**Randolph Pump Station Improvements Project**  
**Solicitation Number: CO-00459**  
**Job No.: 20-8611**

**ADDENDUM NO. 5**  
**January 13, 2023**

SAN ANTONIO WATER SYSTEM  
**RANDOLPH PUMP STATION IMPROVEMENTS**  
**SITE GRADING PLAN I**

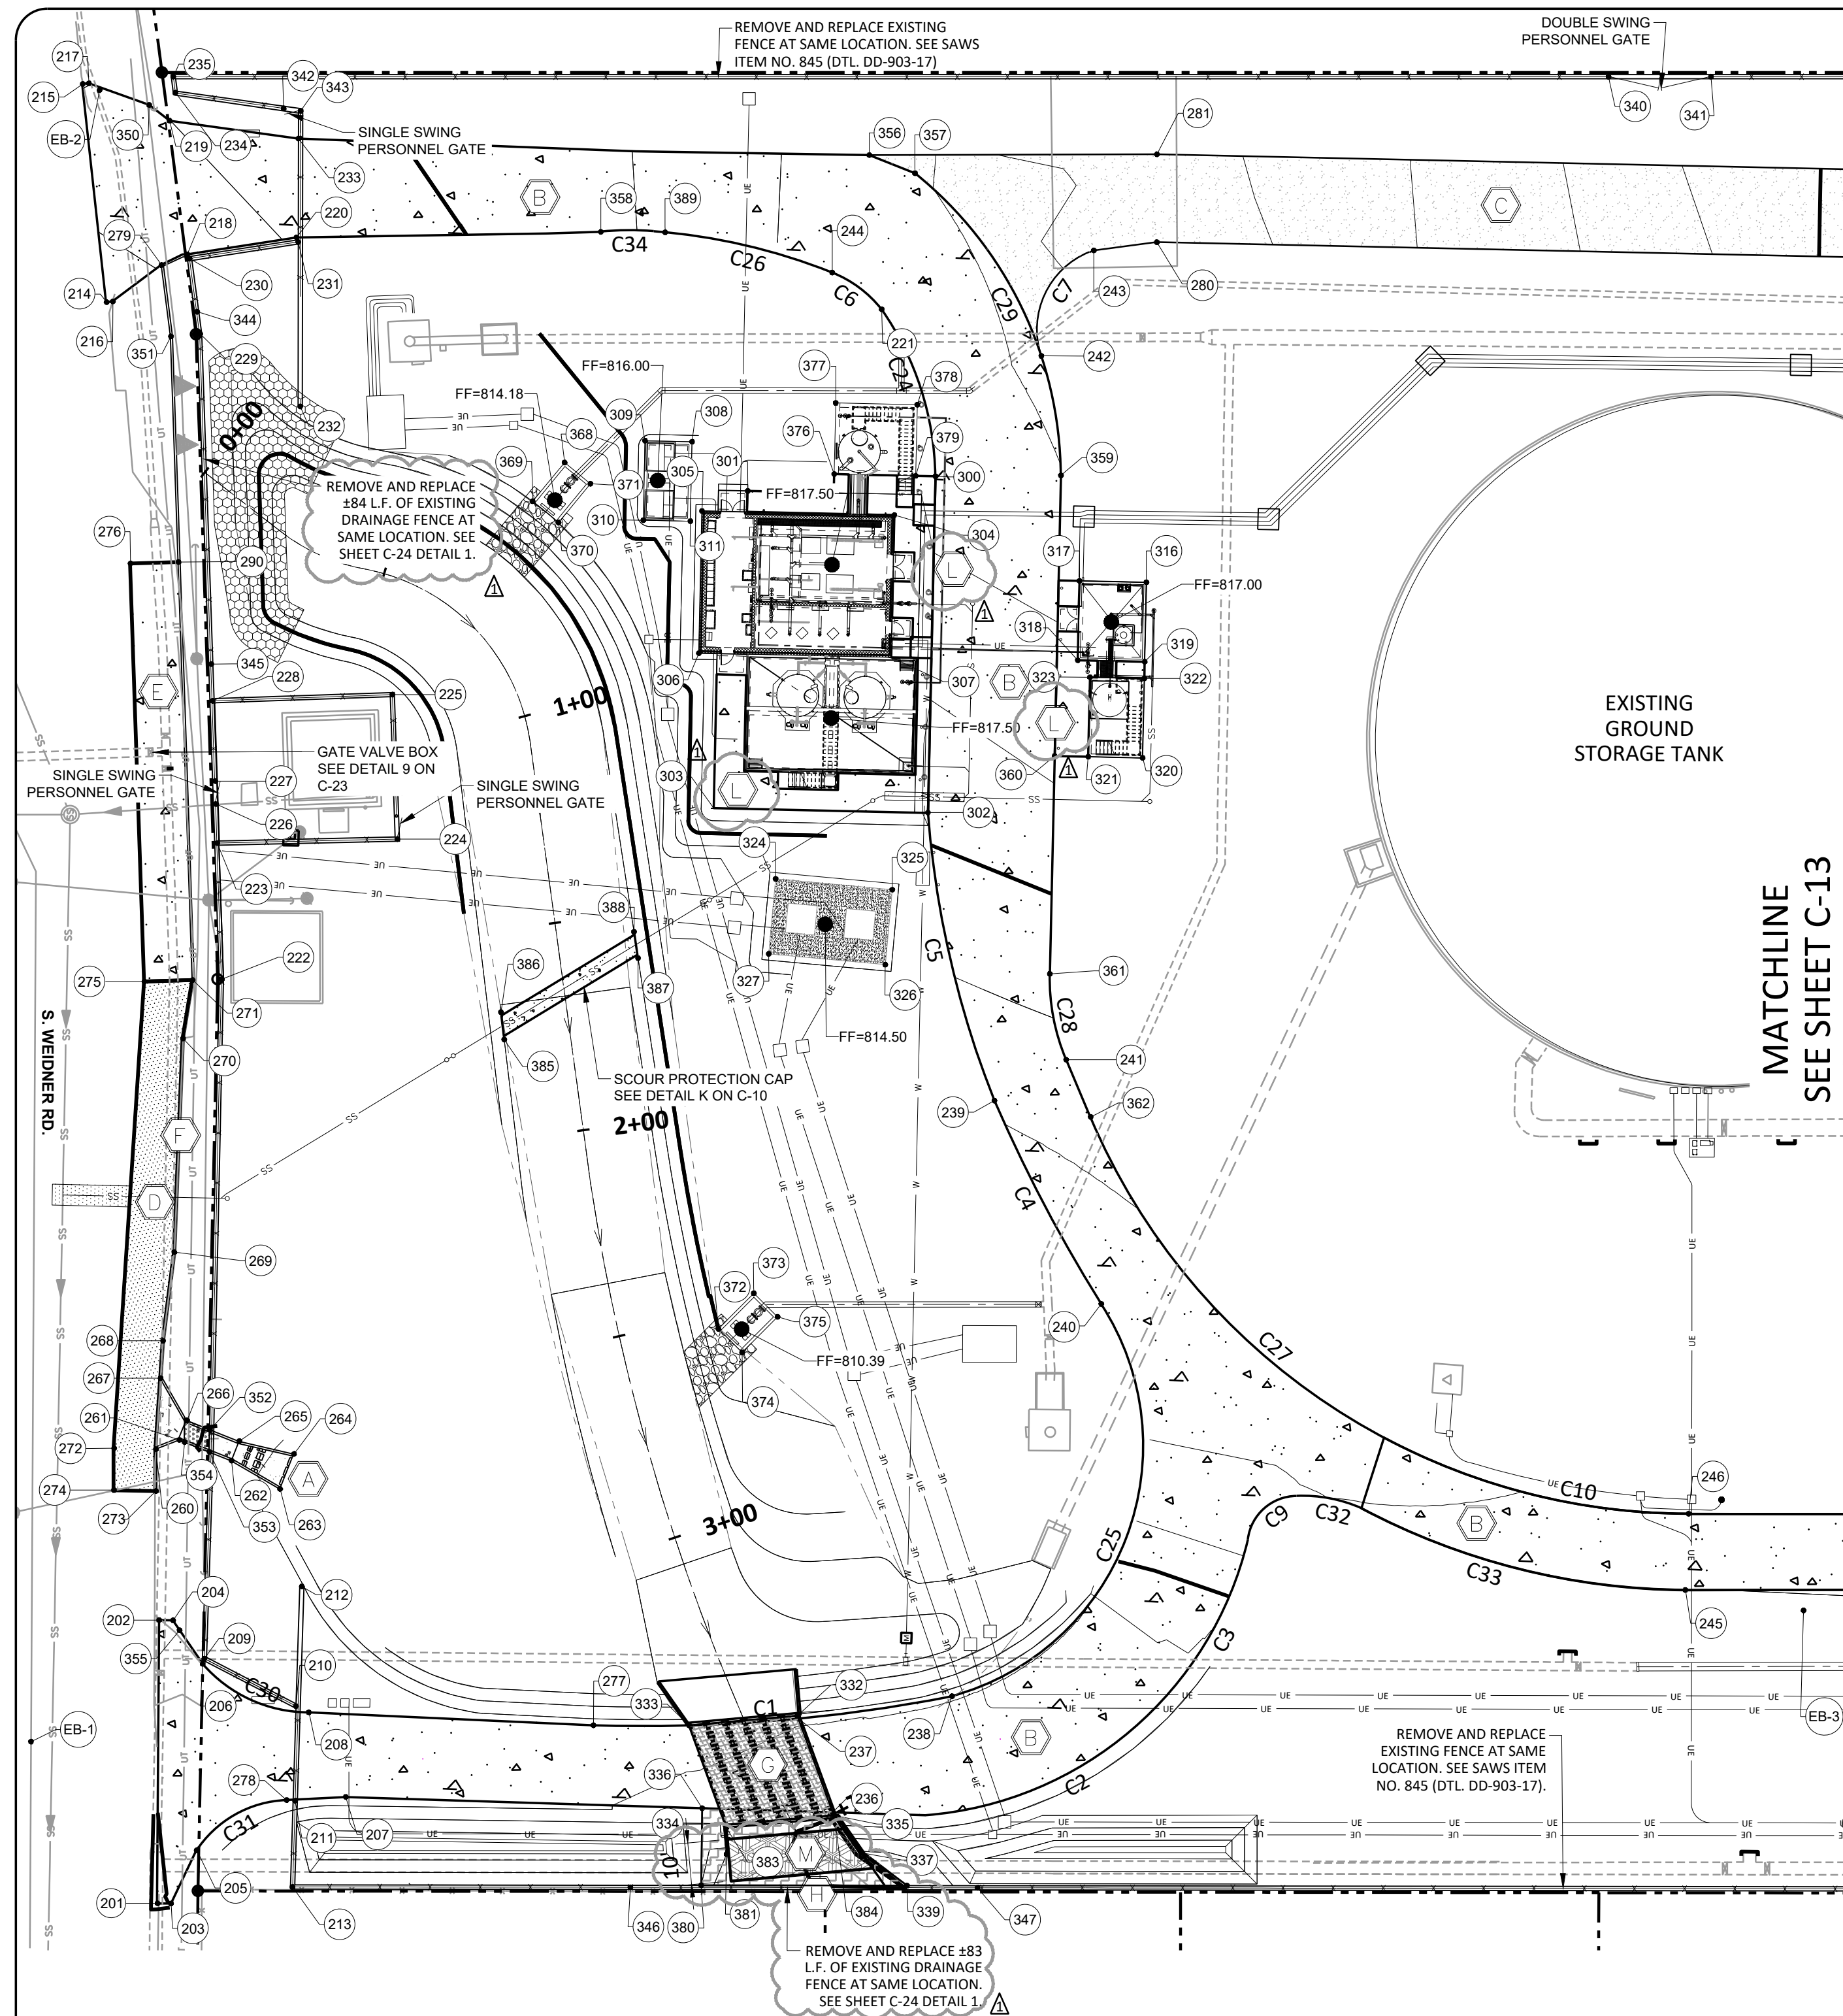
- 68. Question:** Sheet C-10 references Detail 1/C-24 though the limits of installation for this detail aren't clear. Please confirm the length of fencing to be installed per Detail 1/C-24.  
*Response:* Sheet and detail have been updated. See Item No. 4 in the CHANGES TO THE PLANS section in this addendum.

**Add:** Note By Symbol 31 call out pointing to existing electrical switchgear.
- 4. Sheet C-10 Site Grading Plan I**  
**Delete** Sheet C-10 in its entirety **and replace with** revised Sheet C-10 included in this addendum.

SAN ANTONIO WATER SYSTEM  
**RANDOLPH PUMP STATION IMPROVEMENTS**  
ROADWAY MISCELLANEOUS DETAILS

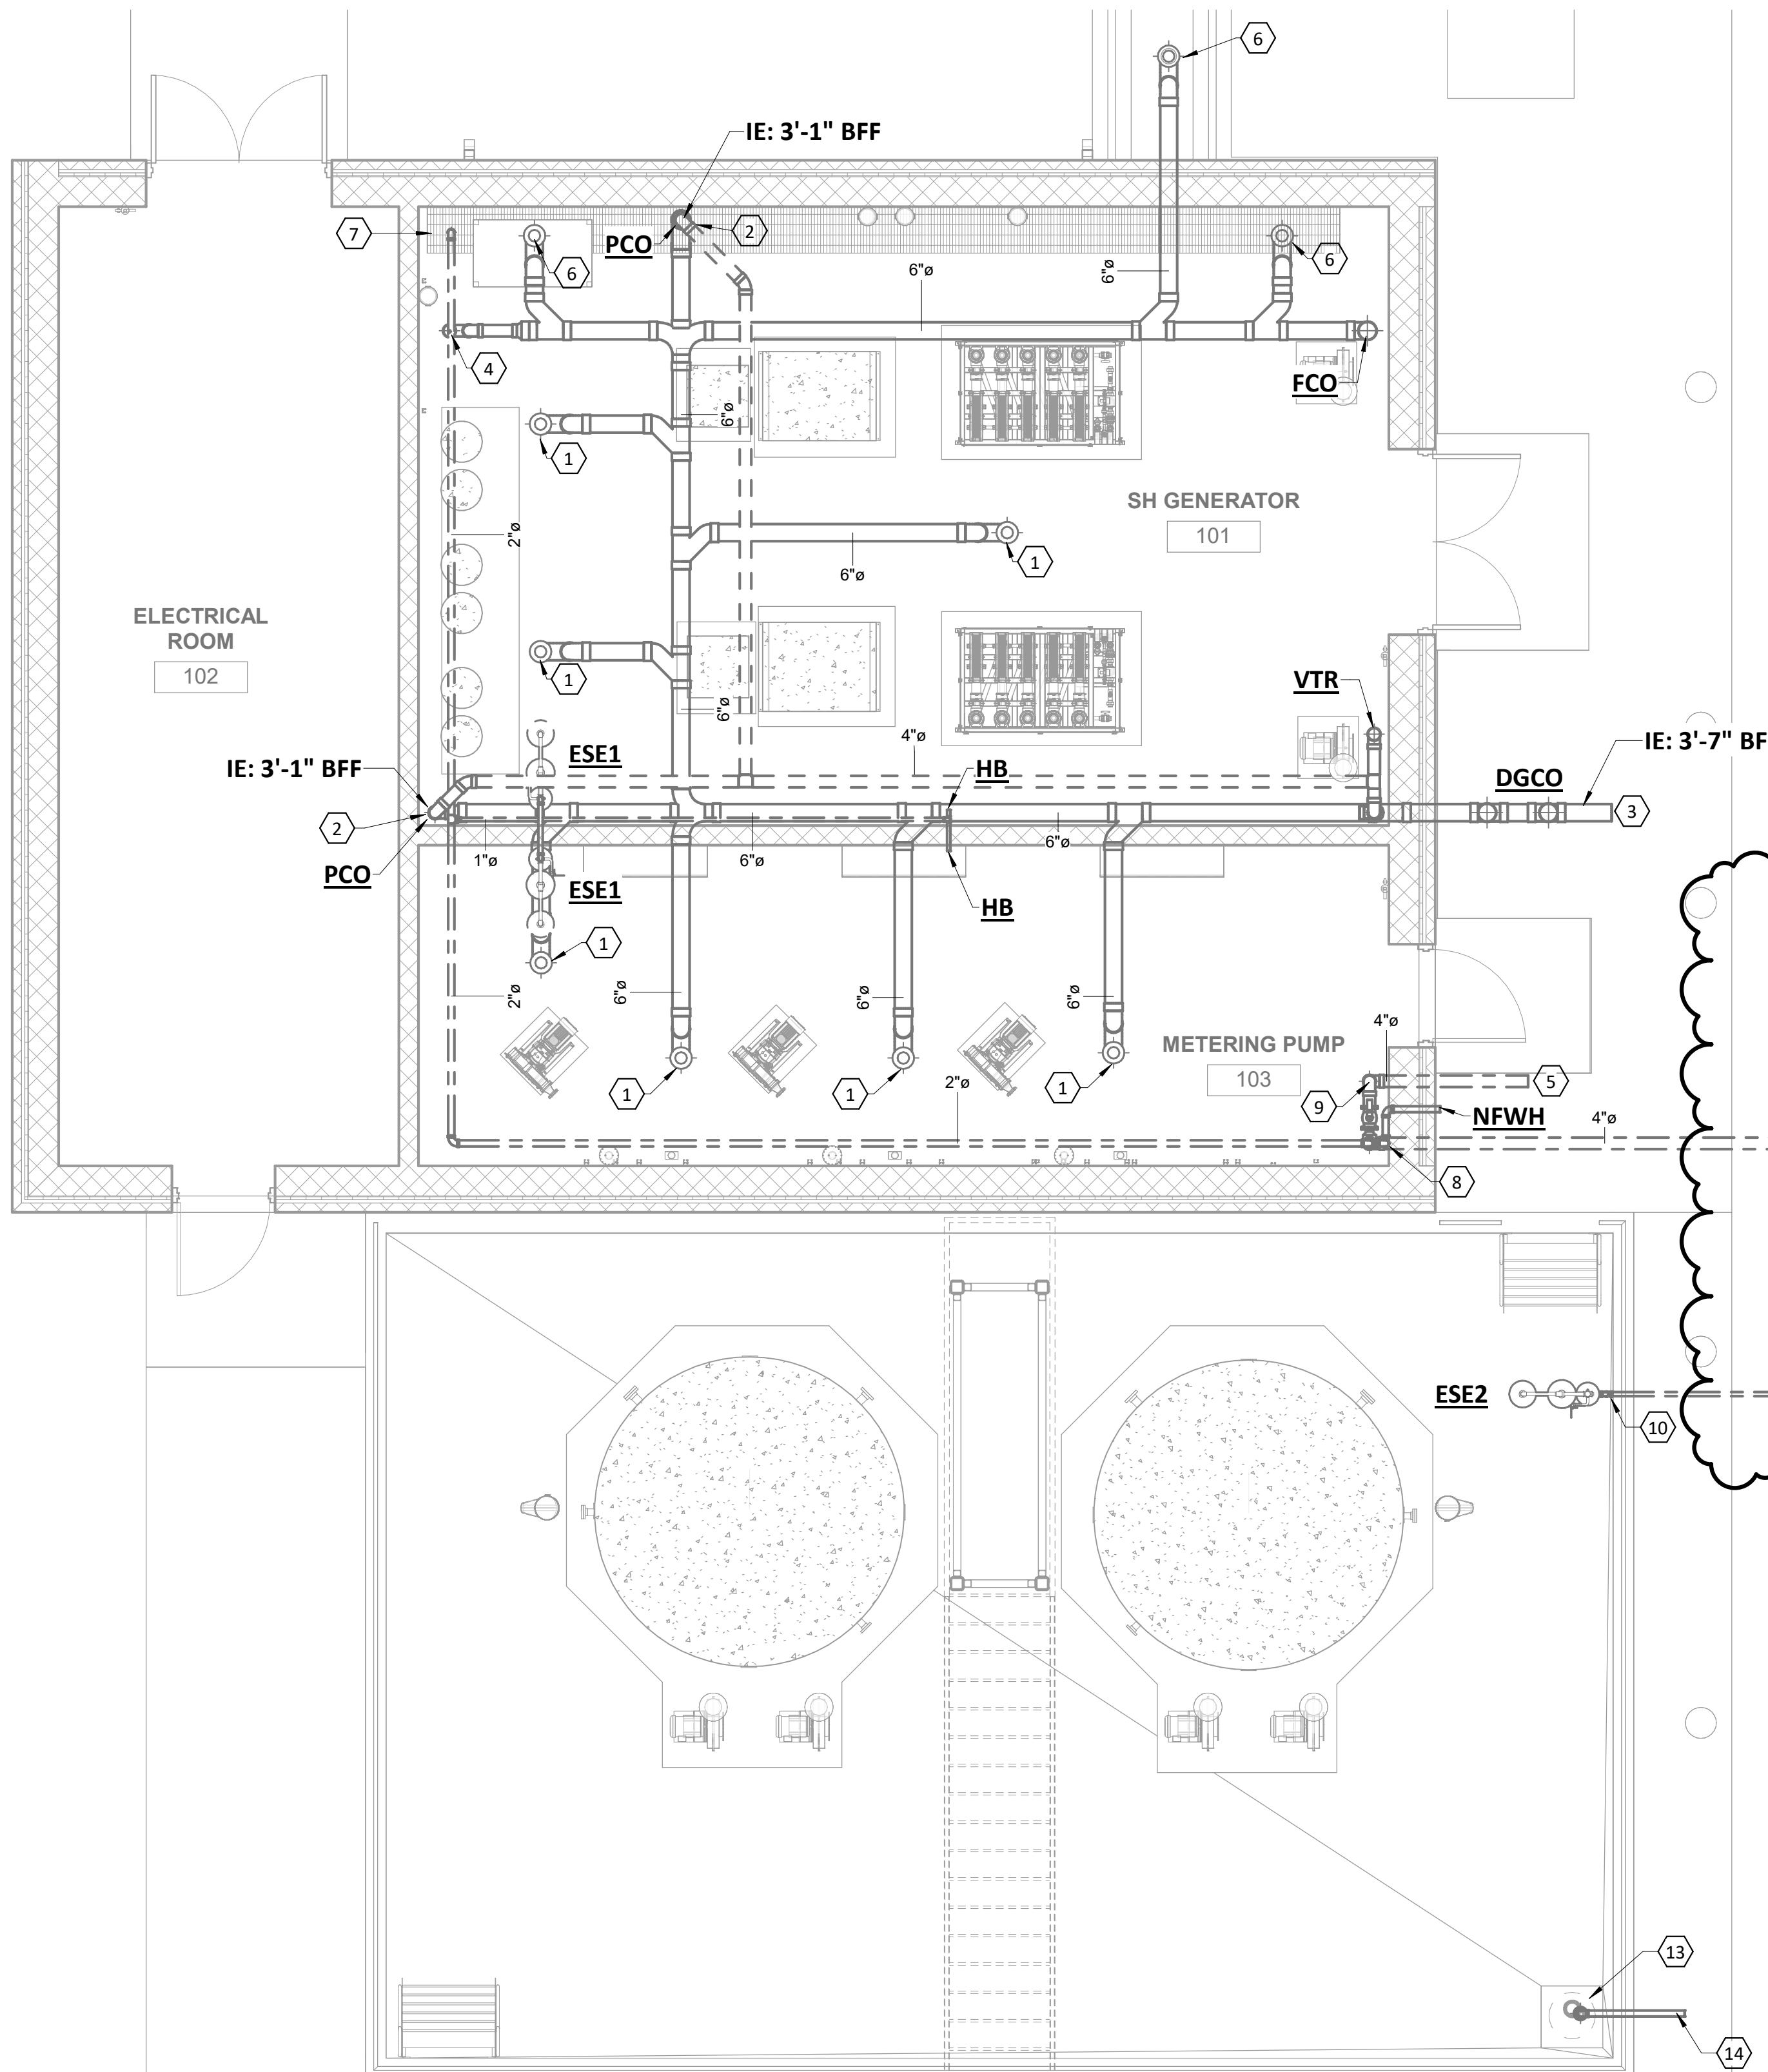
- 7. Question: Detail 5 on drawing C-23 indicates that the compacted sandy gravel road base depth will be "as per loading requirements". Please indicated the depth of subgrade to be used or provide the loading requirements for the Porous Pavement.**  
*Response: Detail has been updated to include depth. See Item No. 8 in the CHANGES TO THE PLANS section of this addendum.*

- 8. Question: On a couple of paving sections for curb and joints on C-23 sht 32 the pavement depth is called out as 10” however on the actual pavement detail its called out as 8.” Please advise on what the depth of concrete pavement needs to be.**  
*Response: There are two concrete pavement depths. One for the concrete pad on S. Weidner Road which is 10-inches thick and the other for the driveway and access road which is 8-inches thick. See Item No. 8 in the CHANGES TO THE PLANS section of this addendum.*

- 36. Question: Detail 5/C-23 indicates the thickness of the Compacted Sandy Gravel Road Base "Varies, as per loading requirements." Please clarify the thickness of the compacted sandy gravel base.**  
*Response: Detail has been updated to include depth. See Item No. 8 in the CHANGES TO THE PLANS section of this addendum.*

- 40. Question: Detail 6/C-23 (Typical Curb & Gutter) calls for Asphalt treated base or asphaltic concrete base under the curb / gutter and HMA. Detail 7/C-23 (Asphalt Replacement) calls for crushed stone base. Please confirm if and where the Asphalt treated base is to be used.**

- 41. Question: Sheet C-12, Item J under the Legend is identified as new sidewalk and references Detail 9/C-23. Detail 9/C-23 is for a valve box installations. Please confirm whether this "sidewalk" is concrete paving and to be constructed per detail 8/C-23.**

*Response: Details 6/C-23 and 7/C-23 have been updated. See Item No. 8 in the CHANGES TO THE PLANS section of this addendum.*

*Response: Sheets and corresponding details have been updated. See Item Nos. 5 and 8 in the CHANGES TO THE PLANS section of this addendum.*

- 8. Sheet C-23 Roadway Miscellaneous Details**  
**Delete** Sheet C-23 in its entirety **and replace with** revised Sheet C-23 included in this addendum.
